SERVICE BULLETIN

Service Bulletin # SSR-4-16-01

Subject: 3-ring risers with stainless steel rings

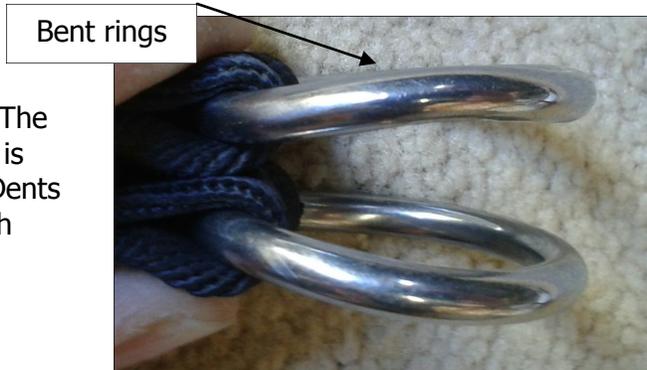
Background: It has been brought to our attention that a stainless steel ring on a 3-ring riser has bent during use. See photo.

Service Bulletin: Stainless steel riser rings should be inspected for bending. Bent ring risers should be returned to Apex BASE and a replacement set of risers will be provided. The tensile strength of the visually deformed ring is still greater than the Type 8 riser webbing. Dents in the area where the rings make contact with each other, are common and not a concern (shown below).

Compliance date: At next repack.
